Our Case Number: ABP-313828-22

Planning Authority Reference Number: SD21A/0271

Re: Demolition of existing building and construction of 5 storey over partial basement mixed use development comprising gastro pub/restaurant with off-licence, 2 retail units, 50 apartments, parking and associated site development works.
Lands at the Silver Granite pub, Palmerstown, Dublin 20

PLANNING APPEAL

Figure 20.0 Proposed site layout plan showing separation distances between proposed development and existing dwelling southeast of the subject site (~30.8m and 36.2m)

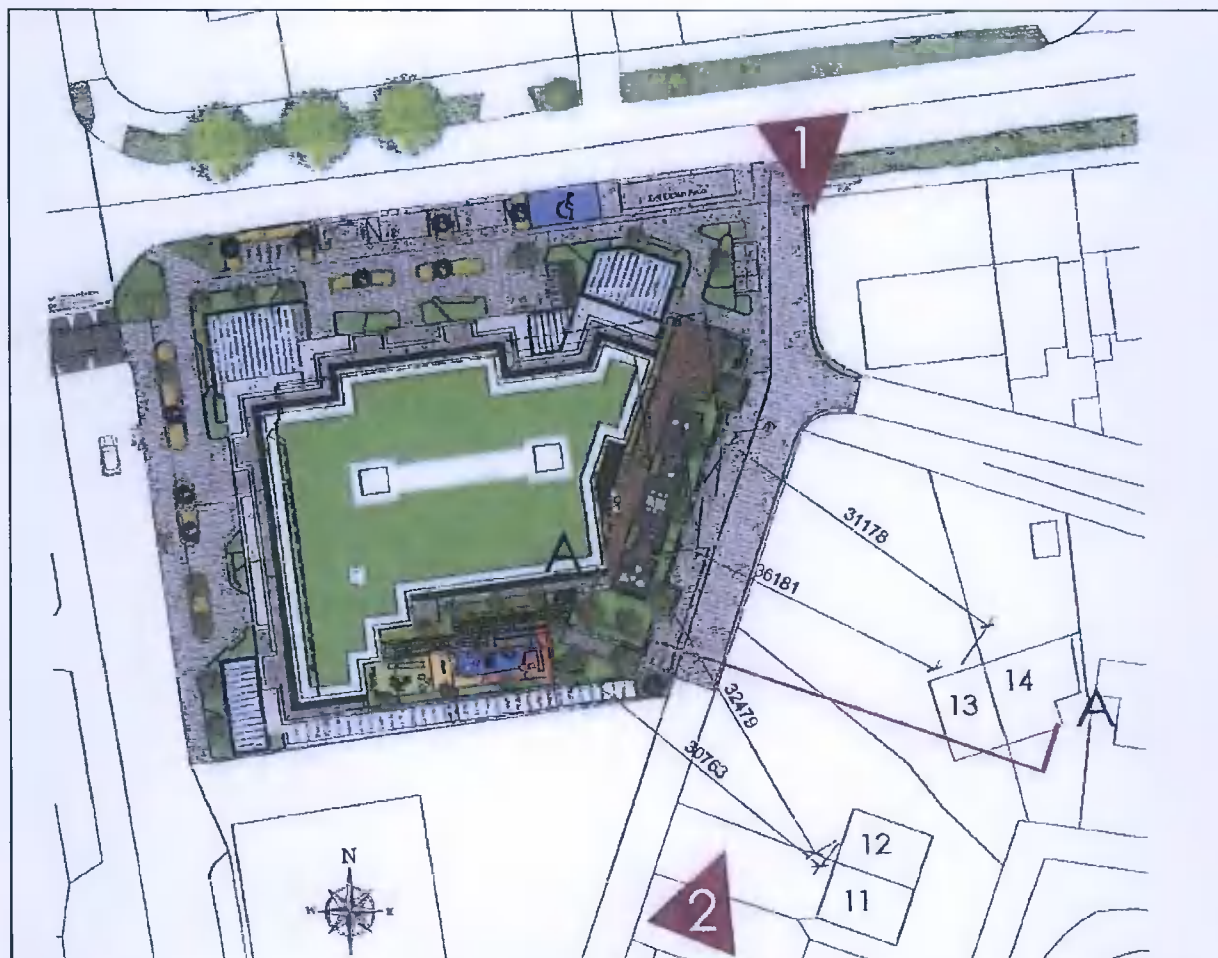
It is considered that the proposed development will result in significant overlooking of the residential dwellings located immediately to the east and south east of the development. Whilst we note a separation distance of between 30.8m and 36.2m has been achieved between the rear, south and eastern, boundary to the properties at Nos. 12-13 Oakcourt Grove and No. 1-3 Wheatfield Road, this distance is considered inadequate given the extent of private balconies proposed on the elevation of this apartment block, see Figure 16.0.

Figure 21.0 Shadow diagram from Daylight and Sunlight report (21 June 18:00 GMT +1)

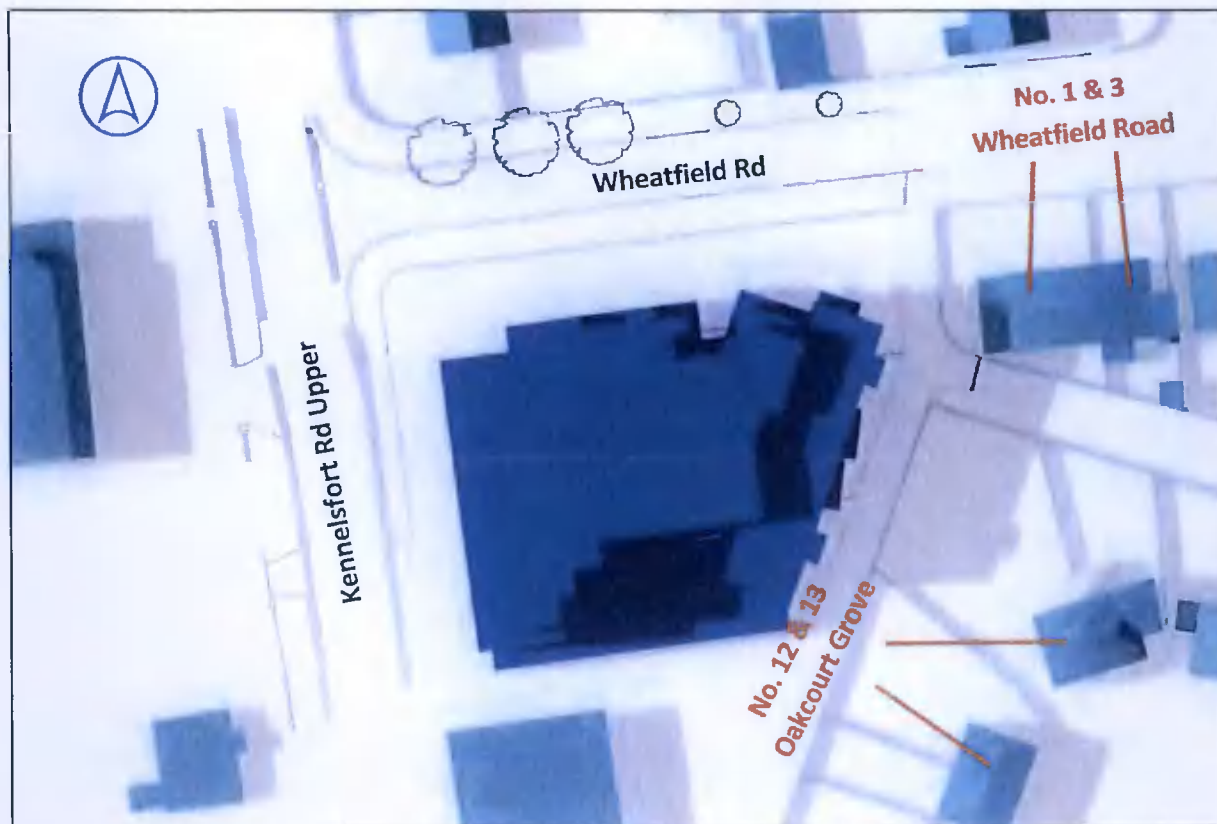
Approximately 6 no. balconies on are located on Proposed Elevation 3 submitted with the project, the vast majority of which will have direct views towards these properties, and in excess of windows above first floor level. It is considered that this elevation will cause unreasonable overlooking of the aforementioned neighbouring residential dwellings, along Wheatfield Road and the laneway accessed from Wheatfield Road, and will also affect residential amenity by way of the perception of overlooking. The proposal is stated to be *'a high-quality development at an underutilised site within an urban setting'* and that *'the proposed development will provide appropriate levels of daylight and sunlight and will not give rise to adverse overshadowing'*. We refer to the proposed shadow diagram from the Daylight and Sunlight report submitted by applicant, see Figures 17.0-18.0.

Figure 22.0 Shadow diagram from Daylight and Sunlight report (21 March 17:00 GMT)

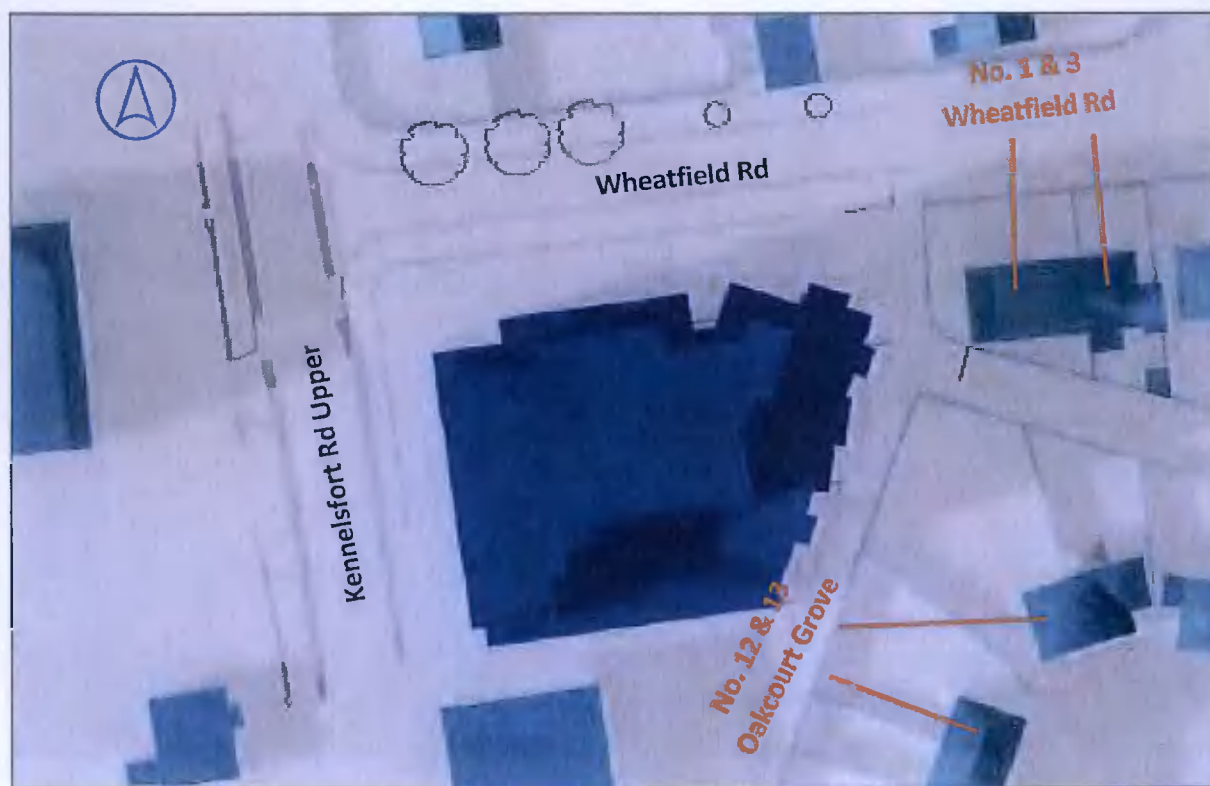
As noted above, the first through fifth floors of the proposed development will serve as dual aspect residential units. If the proposed development was permitted, it would result in severe overshadowing due to the height difference between the mixed-used development and the existing residential dwellings. The overbearing structure which is quite significant in mass and scale in the local context would have detrimental effects on the residential amenity currently afforded to these dwellings.

Figure 24.0 3D Study looking southwest and down laneway from Wheatfield Road.

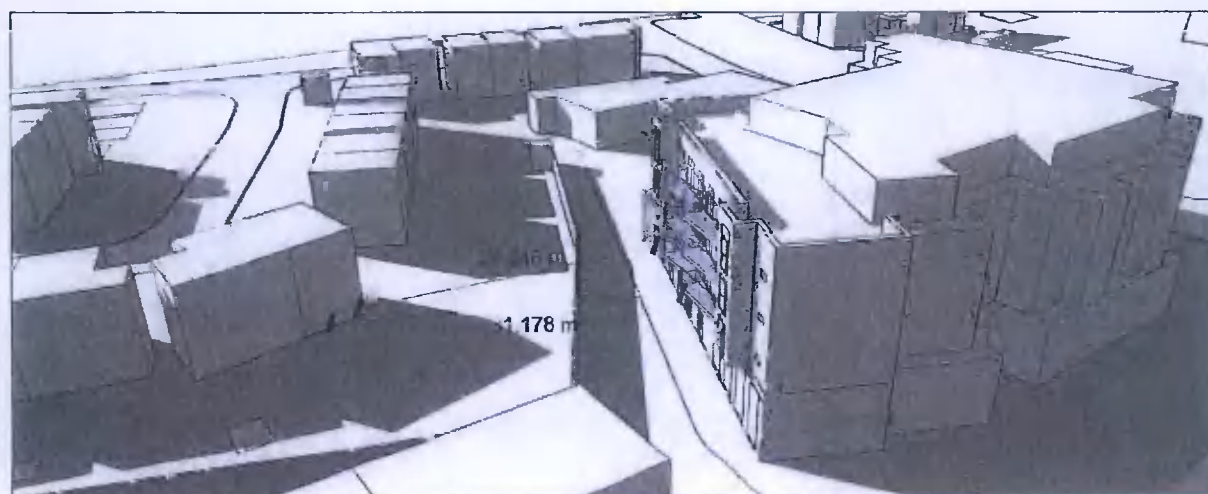
The proposed development directly contravenes objectives set out in the South Dublin County Council Development Plan 2016-2022 with relation to heights and privacy. The following objectives are relevant to this appeal:

Figure 25.0 3D Study looking northeast and from laneway toward Wheatfield Road.

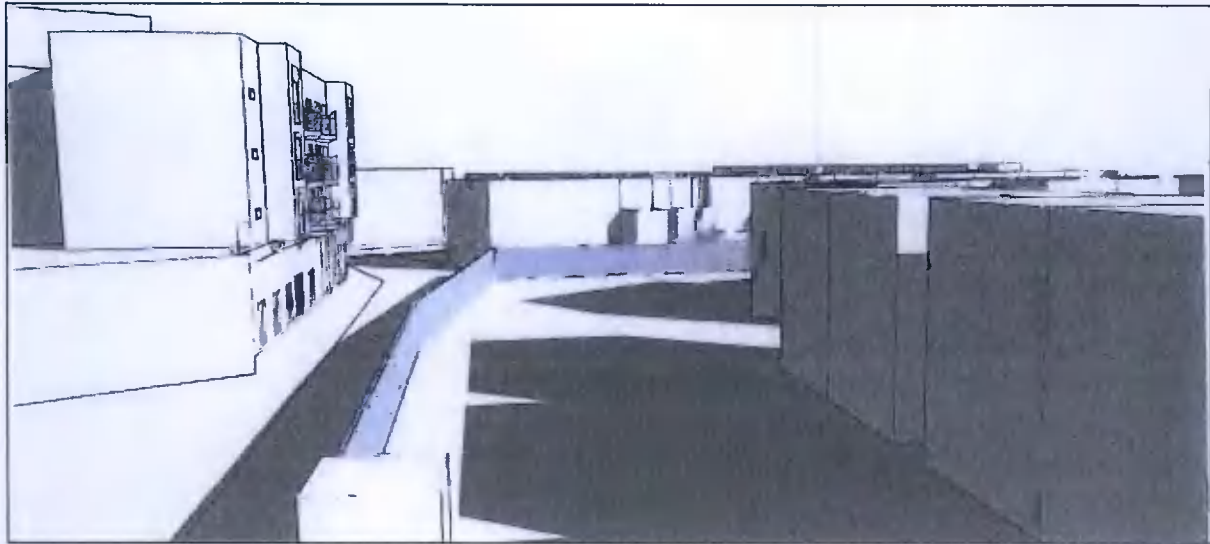
The proposed development at a 5-storey maximum, as submitted, would reduce the amenity afforded to the neighbouring building due to significant in mass and scale in the local context.

The development is over-scaled and bulky and is expected to result in overshadowing of these properties, particularly No. 1 & 3 Wheatfield Rd, Johnstown, Dublin 20 as well as the rear yards of Nos. 12 & 13 Oakcourt Grove, Johnstown, Dublin 20.

Figure 26.0 Contextual elevation of the proposed development as it interfaces with Kennelsfort Road Upper.

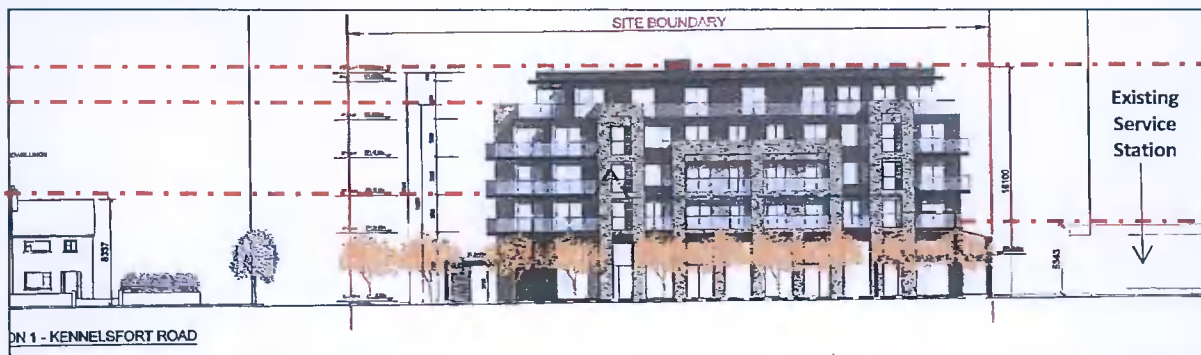
The below contextual images illustrate the impact and inappropriate form of development which causes overbearing, does not ensure the protection of the streetscape and skyline within the immediate area and establishes a negative precedent for the redevelopment of opportunity sites within the area.

Figure 29.0 Aerial view showing back lands of Nos. 12 & 13 Oakfield Road residences (outlined using orange).

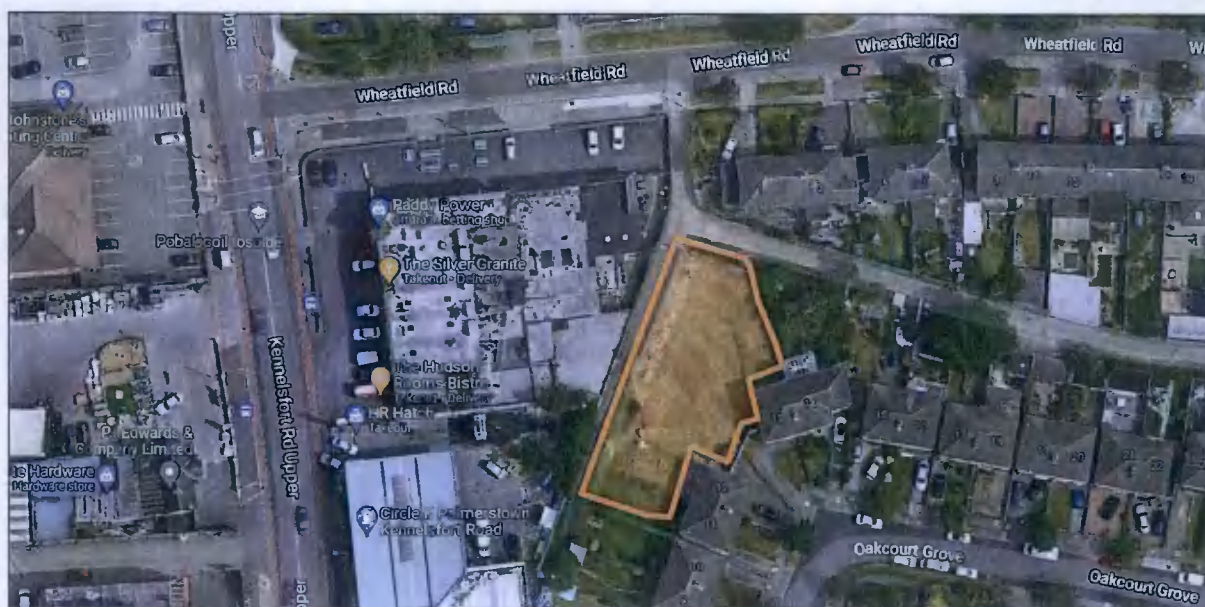
It is submitted that the proposed development would reduce the development opportunities afforded to No. 12 & 13 Oakfield Road due to the excessive scale and bulk of the development and its proximity to the site boundary. The rear backlands of these properties have potential for redevelopment in which this proposal would cause devaluation to their properties. It would be unfeasible for the owners to develop further on their properties as the proposed development would cause overshadowing, rendering potential development uncompliant with national standards.

It is noted that the development will exceed the height and massing of existing mixed-use buildings along Lower Kennelsfort Road and therefore will be out of character with the surrounding area. In an area that is characterised by single and two-storey buildings, it is considered that a development that reaches a height of 3-storeys and is located on the boundary of the neighbouring property is unacceptable.

Figure 32.0 The subject site entrance proximate to the junction of Wheatfield Road and Kennelsfort Road Upper.

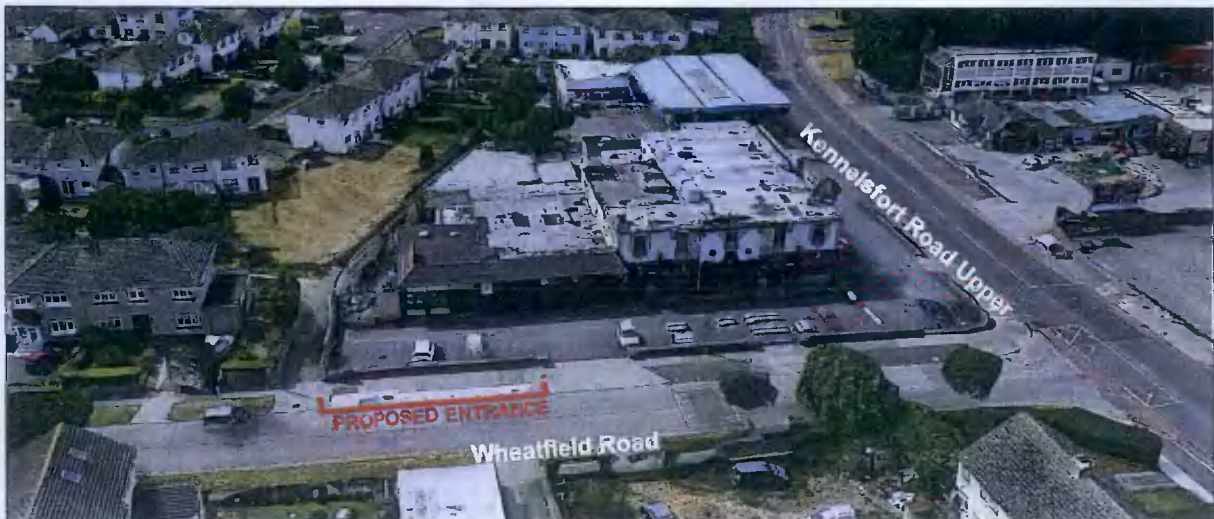
The proposed access to the site relies on the amount of occupants utilising public transit and a disputed parking lot currently shared between Palmerstown Shopping Centre and Silver Granite Pub patrons. The pedestrian passage proposed does not comprise stopping measures and its location approximate to the junction will have a serious impact on all road users which may lead to major traffic hazards and accidents. We urge the Board to refuse permission on this basis and insist that any future applications to South Dublin County Council must be accompanied by a full traffic impact assessment carried out by a qualified consultant.
